SUNDRY NOTICES AND REPORTS ON WELLS

Chesapeake Operating, Inc.
NMNM04229C: Little Eddy Unit 7
1800' FNL & 1650' FEL, Sec. 5, T21S-R32E
Lea County, New Mexico

RE: Plugging and Abandonment Requirements, Condition of Approval

Field: HAT MESA (DELAWARE)
County: LEA
State: NEW MEXICO
Location: SEC 5, 21S-32E, 1799 FNL & 1650 FEL
Elevation: GL 3,561.00 KB 3,571.00
KB Height: 10.00

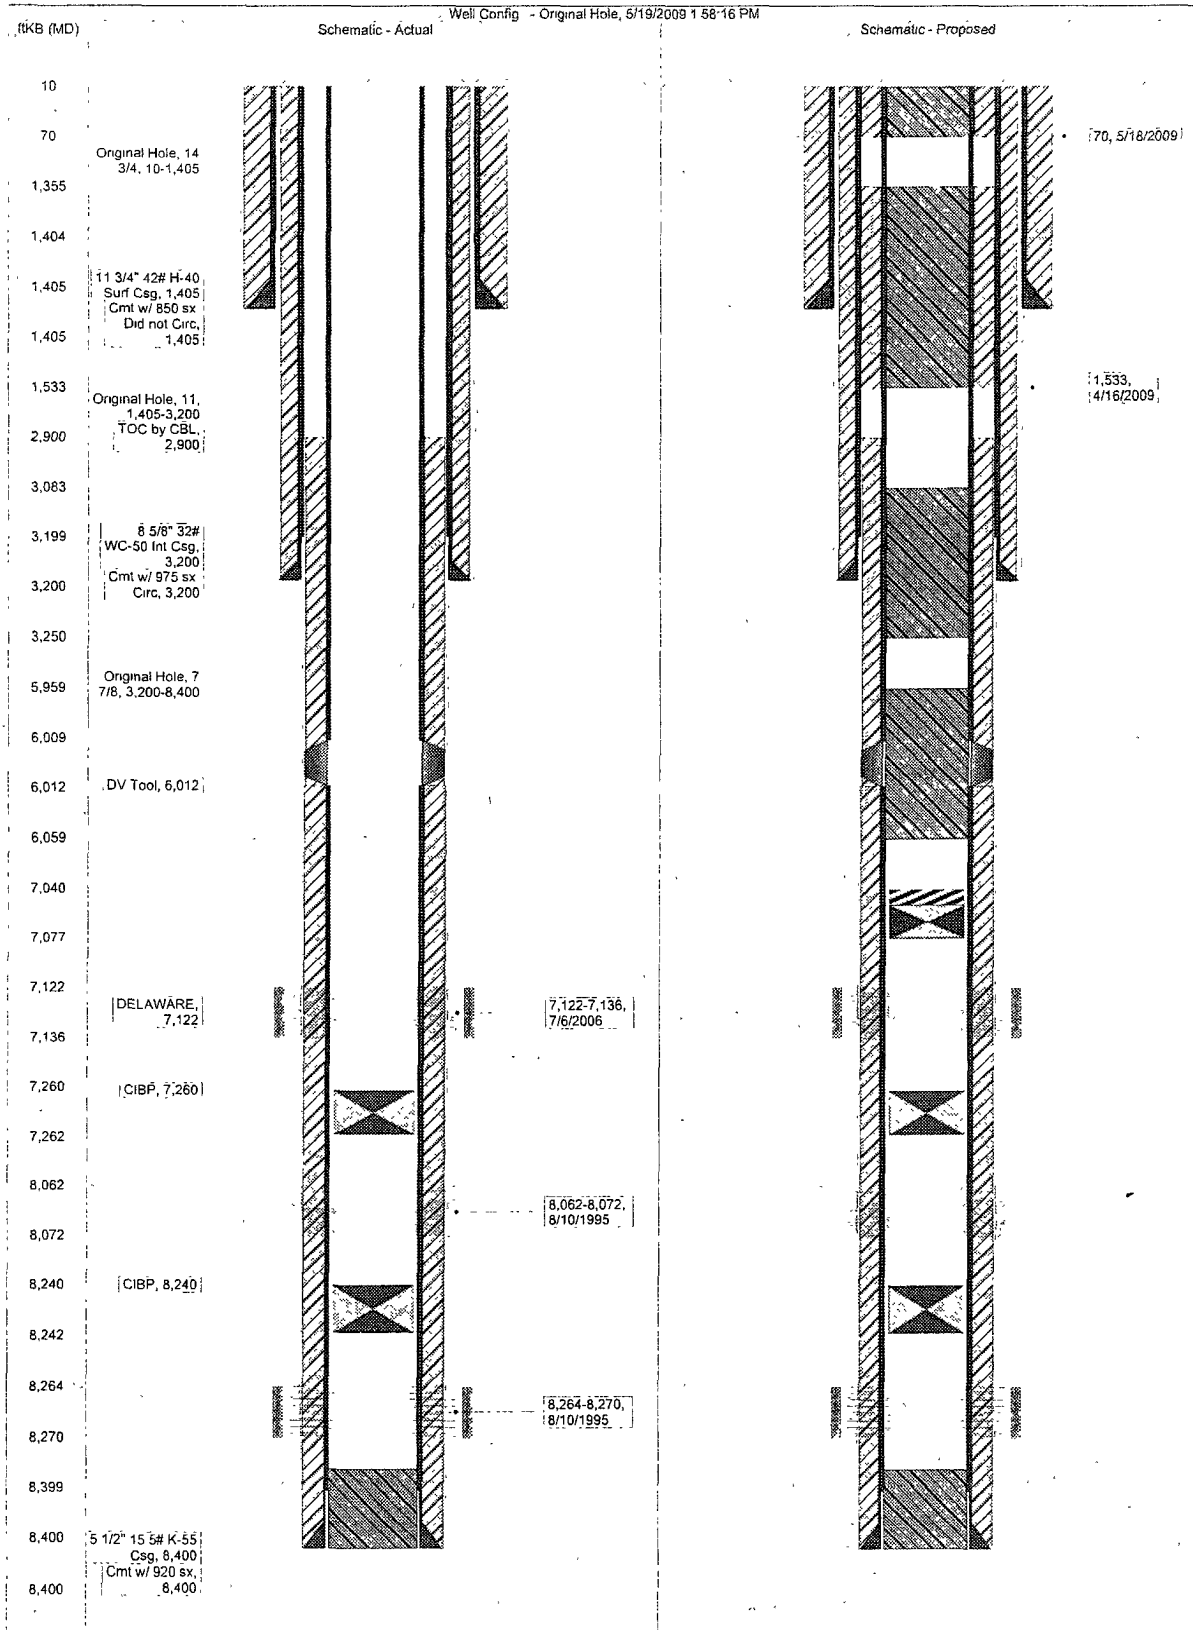
1. OK.
2. OK.
3. OK.
4. OK.
5. OK.
6. 25 sack minimum plug.
7. Well is located inside the R111P Potash, which requires a solid plug in and out of all casings thru the salt section. This will require either, spotting a plug from 3250'-2900', perforating @ 2900' and circulating cement in and out of the 5-1/2" casing from 2900'-1332'. WOC and tag. Then continue with step 9. Perforating the 5-1/2" casing @ 60' and circulating to surface.

Option 2: Would be to, cut and pull casing @ 2900'. Then RIH to 3250' and spot cement from 3250'-1332' (may need to stage). WOC and tag. Then spot the surface plug from 60' to surface.
